PCN-717 ECO 170508A

Kit Part Number	New Part Number	Old Part Number	Description
778475-01	188414E-02	188414D-02	CABLE ASSEMBLY, USB-485, 2M

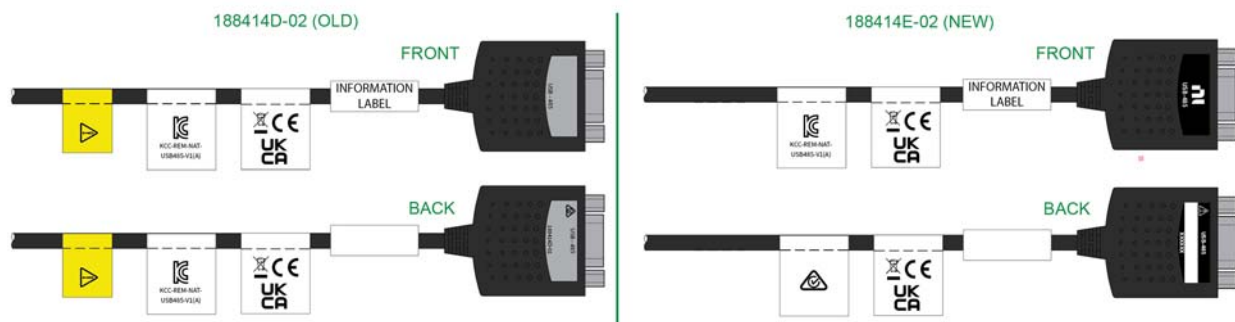
Labeling was updated to simplify product sustaining effort and improve cosmetic appearance as shown in the figure below (labels not to scale).

- Overlay color changed to black
- NI logo added to overlay
- Caution symbol moved from flag label to overlay
- RCM mark moved from overlay to flag label
- Part number removed from overlay (still present on information label)

The updates are only cosmetic. However, the change in color and size of the barcode area may affect the ease of scanning on some readers.
